STAFF RECOMMENDATION
3538 Richland Avenue
Lot 20, Richland Hall Development
March 20, 2019

Application: New Construction—Infill
District: Richland-West End Neighborhood Conservation Zoning Overlay
Council District: 24
Base Zoning: RS7.5
Map and Parcel Number: 10409030300
Applicant: Chad Gore, Mike Ford Builders
Project Lead: Jenny Warren, jenny.warren@nashville.gov

Description of Project: Application to construct a new single family infill with an attached garage at basement level.

Figure 1: Proposed infill at 3538 Richland Avenue.

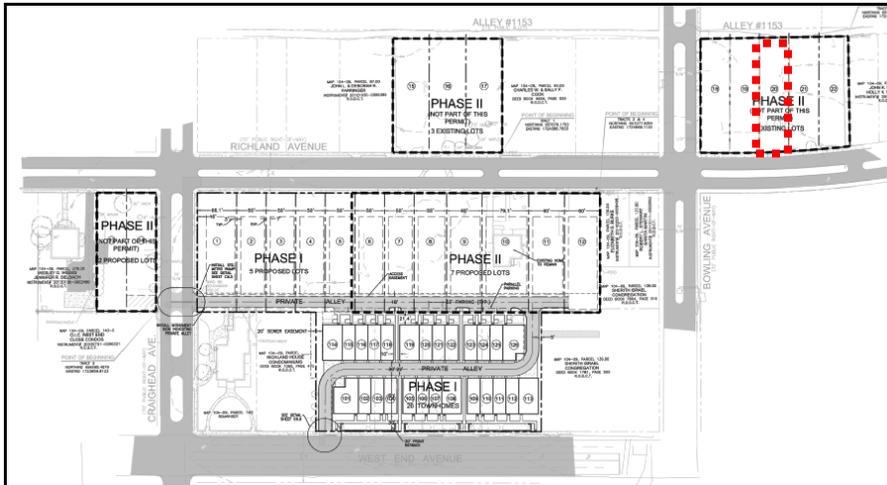
Height & Scale: The proposed infill will be two stories and will have a maximum height of about thirty-five feet, one inch (35'1") above the foundation height, with about one foot, six inches (1'6") of foundation height. Staff finds that the proposed height is similar to the heights of historic houses in the immediate vicinity, which range from twenty to thirty-seven feet (20'-37') tall. It is also in keeping with what has been approved in the past for the infill houses in this development.

Because of the steep slope of the lot, the foundation height will vary from about one foot, six inches (1'6") on the front, to about ten feet (10') tall near the back of the infill. At the rear, a full height walk-out basement level will be clad in brick, rather than foundation material. Staff recommends inspection of the foundation and the finished floor height to ensure that the height of the foundation at the front is appropriate for the historic context.

Roof form: The primary roof is hipped with a front-facing gable: both have a 9/12 slope. The rear has a series of hips, all with a 6/12 slope. The front porch has a shed roof with a 3/12 slope. Staff finds that the roof forms are appropriate for an infill house in the overlay, and finds that the roof forms meet Section II.B.1.e. of the design guidelines.

Proportion and Rhythm of Openings: The proposed windows on the infill are generally twice as tall as they are wide, thereby meeting the historic proportion of window openings. There are two small squared windows near the back, on the second level. Staff finds these to be appropriate, as this area reads as an enclosed porch, where different window proportions would be common, and because they are located so far back along the side façade. All window groupings have a four to six inch (4"-6") mullion in between the individual window openings. There is one fairly large expanses of wall space without a window or door opening on the right side elevation, but it is more than thirty feet (30') back from the front elevation.

Staff recommends verification of the construction height of the foundation and floor systems in the field to ensure that the finished floor line of the new construction is compatible with the historic context. With this condition, staff finds that the height and scale meet Sections II.B.1.a and II.B.1.b of the design guidelines.

Figure 3: The proposed footprints and setbacks for Lots 18-22 of the Richland Hall development.

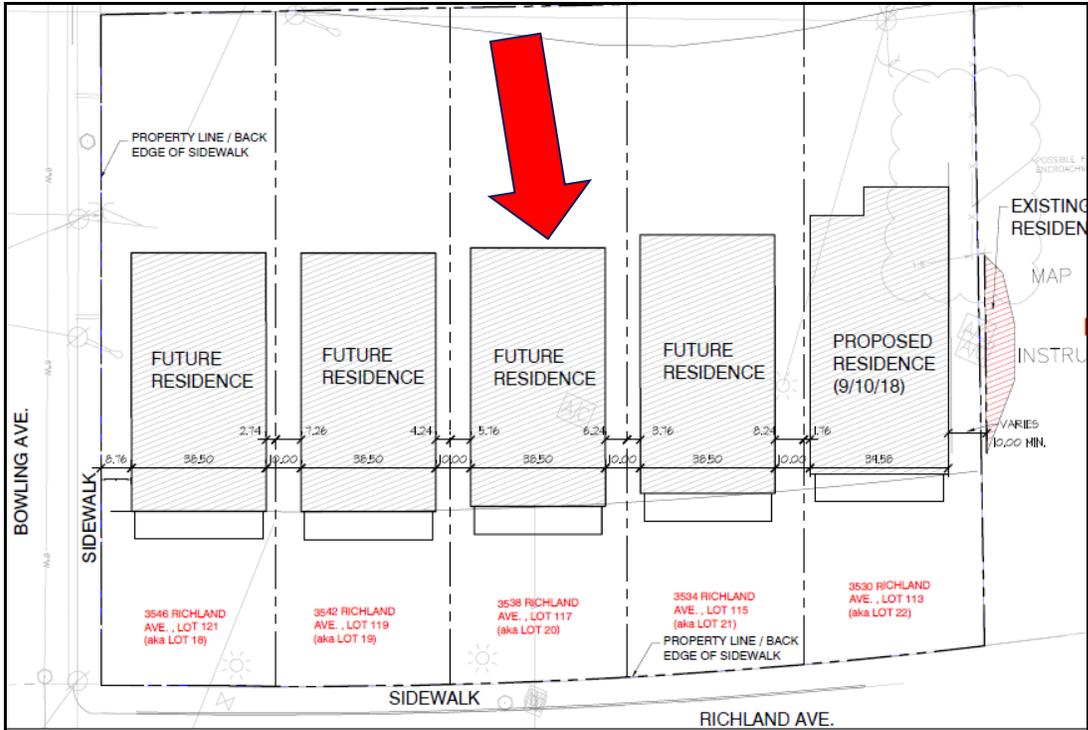
Setback & Rhythm of Spacing: This infill for Lot 20 of the Richland Hall development is the fourth of five houses to be developed for this block. As such, it is helpful to look at the proposed setbacks of all five infills proposed for this section of Richland Avenue.

The front setbacks for the five infills will gradually step back, matching the curve of Richland Avenue and transitioning the front setbacks to the historic house at 3526 Richland Avenue. To the right of the subject property, the two infills at 3530 and 3534 Richland Avenue (lots 22 and 21), were approved to have front setbacks of approximately fifty-eight feet, six or seven inches (58'6" or 7"). This setback is similar to the front setback of the historic house at 3526 Richland Avenue, when the curve is taken into account. The infill to the left, at 3542 Richland Avenue (lot 19), was approved in February 2019 with a setback of approximately fifty-seven feet, eleven inches (57'11"). The proposed infill at 3538 Richland (lot 20), is shown with a setback of approximately sixty feet, two inches (60'2"). Given the curve, this appears to maintain the consistent setback. Staff recommends that the field staking be checked by MHZC staff in the field, to ensure that the proposed setback maintains the appropriate consistent setback shown in Figure 3.

The house will be six feet, six inches (6'6") from the east property line and five feet, six inches (5'6") from the west property line. The rear will be about sixty-one feet (61') from the rear property line.

Staff finds that the proposed infill meets Section II.B.1.c of the design guidelines.
